**CALIFORNIA COASTAL COMMISSION**

AMENDMENT REQUEST  
STAFF REPORT AND PRELIMINARY RECOMMENDATION

Application No.: 6-99-24-A1

Applicant: McMahon Development Group

Site Plan (showing parking area and grated light opening above bridge)

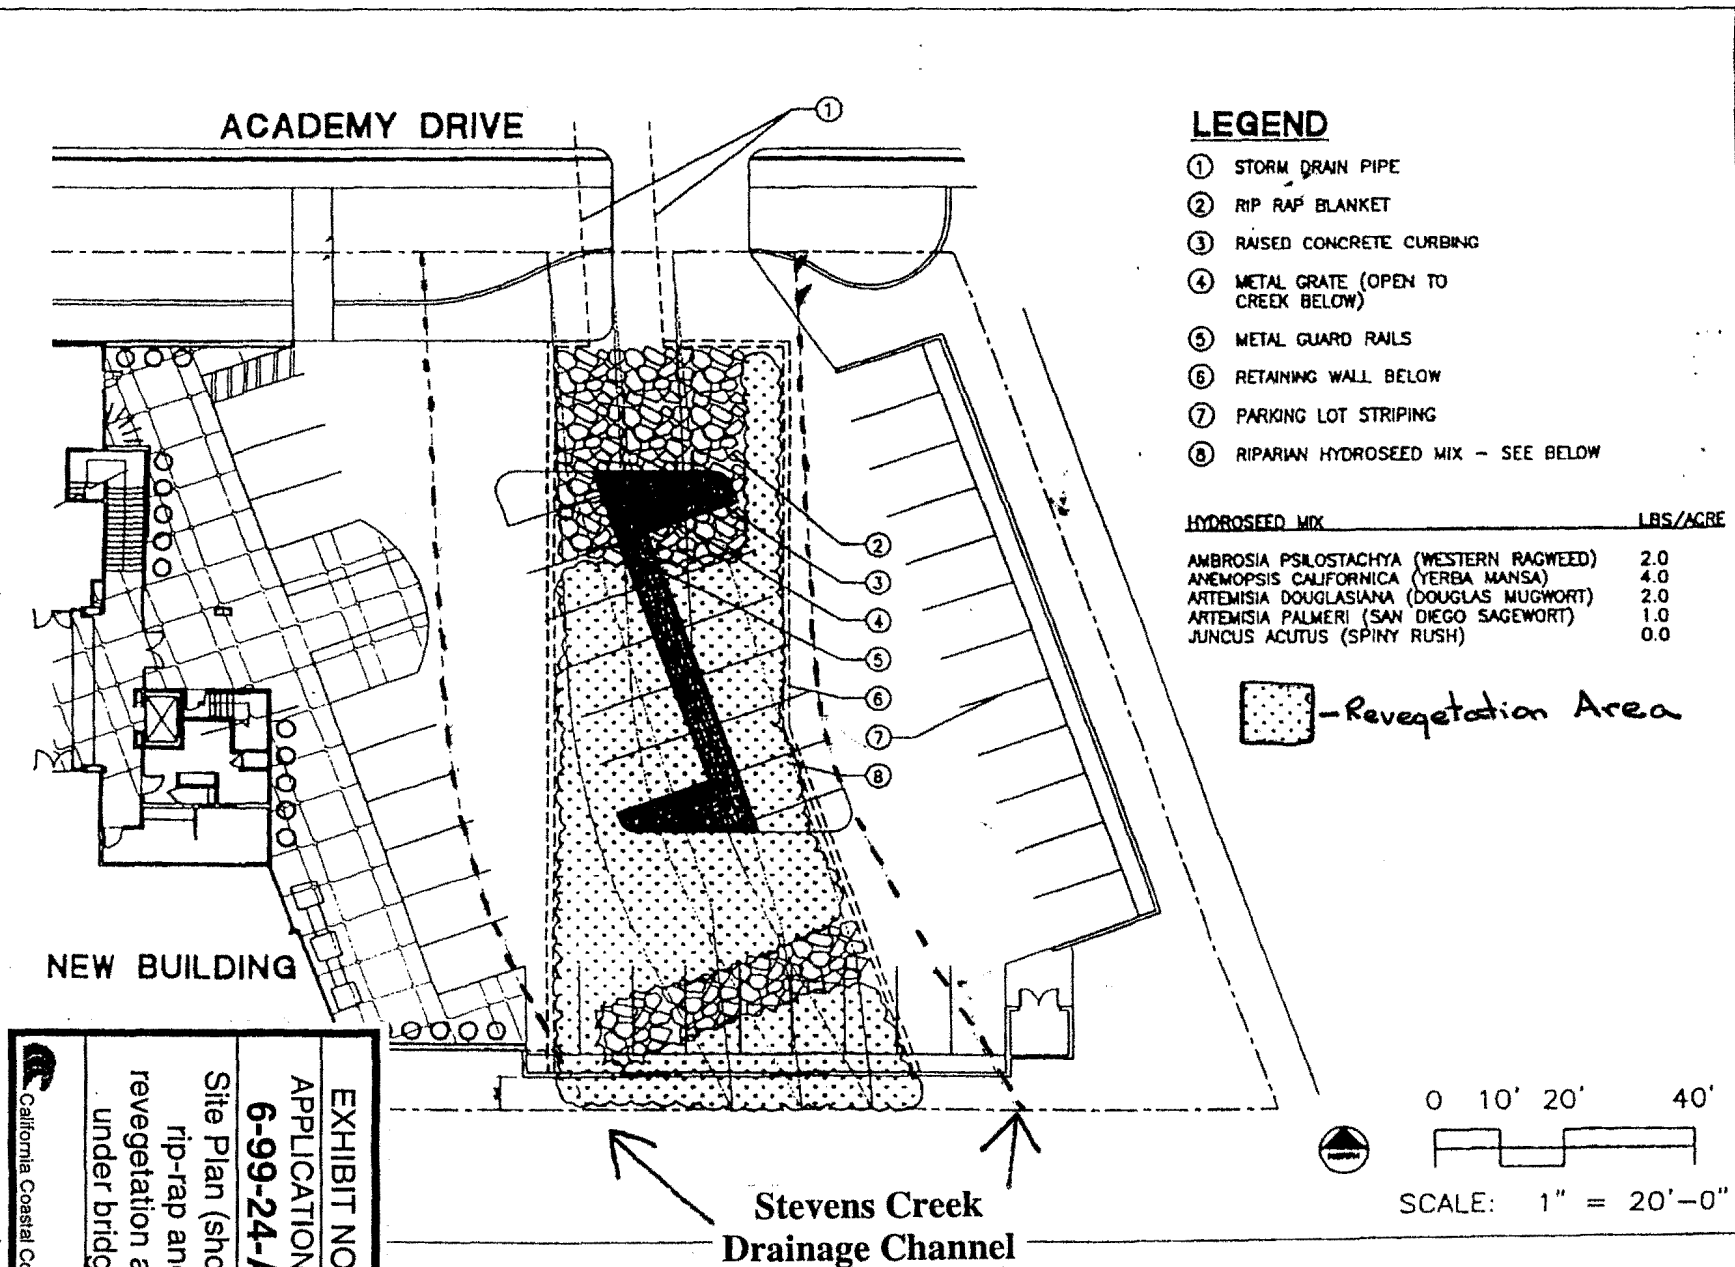
acres under the proposed bridge. The bridge is proposed to include light openings to allow for limited lighting of the proposed revegetation site below. The proposed impacts to wetlands and stream alteration associated with the proposed amendment request are inconsistent with several policies of the Coastal Act. Feasible alternatives are available that allow for development of the commercial building with parking that avoids the need to fill wetlands or alter the existing open channel. Therefore, staff is recommending denial of the proposed permit amendment.

The proposed amendment involves the removal of existing rip-rap within the bed and banks of Stevens Creek drainage channel within the subject property, construction of a bridge over the channel to create a parking lot above, revegetation of a portion of the channel bed and banks, and installation of rip-rap energy dissipaters within the channel. The proposed development will impact approximately .07 acres of wetlands and approximately .13 acre of banks within the channel associated with the removal all existing rip-rap within the channel on the subject property some of which lies up to 6 feet below ground. As a result, all existing wetlands and stream resources will be removed. To mitigate the impacts of the rip-rap removal, construction of the bridge which has shading impacts to the stream and installation of two rip-rap energy dissipaters, the applicant proposes to revegetate an area of approximately .08 acre under the bridge with a hydroseed mix of several low light sensitive native, non-invasive wetland occurring plant species. The bridge design includes an open grate feature to allow light to pass beneath the bridge to accommodate plant growth in the area proposed to be revegetated.

The Commission hereby denies the proposed amendment to the coastal development permit on the grounds that the development as amended will not conform with the policies of Chapter 3 of the Coastal Act and will prejudice the ability of the local government having jurisdiction over the area to prepare a Local Coastal Program conforming to the provisions of Chapter 3. Approval of the amendment would not comply with the California Environmental Quality Act because there are feasible
